LASSO OIL & GAS LLC
CONTINENTAL 63S100W 17SESW
Location # 315226

COLORADO
Oil & Gas Conservation
Commission
Department of Natural Resources

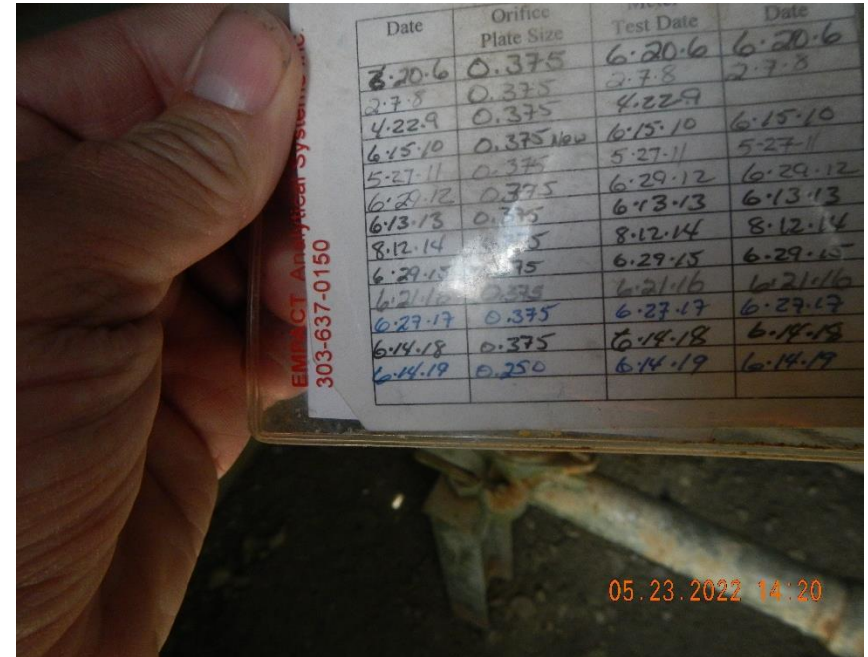
No battery sign at tank battery. Label doesn't meet Rule 605.h. (missing information). No NFPA sticker, no operator name and no operator contact number.
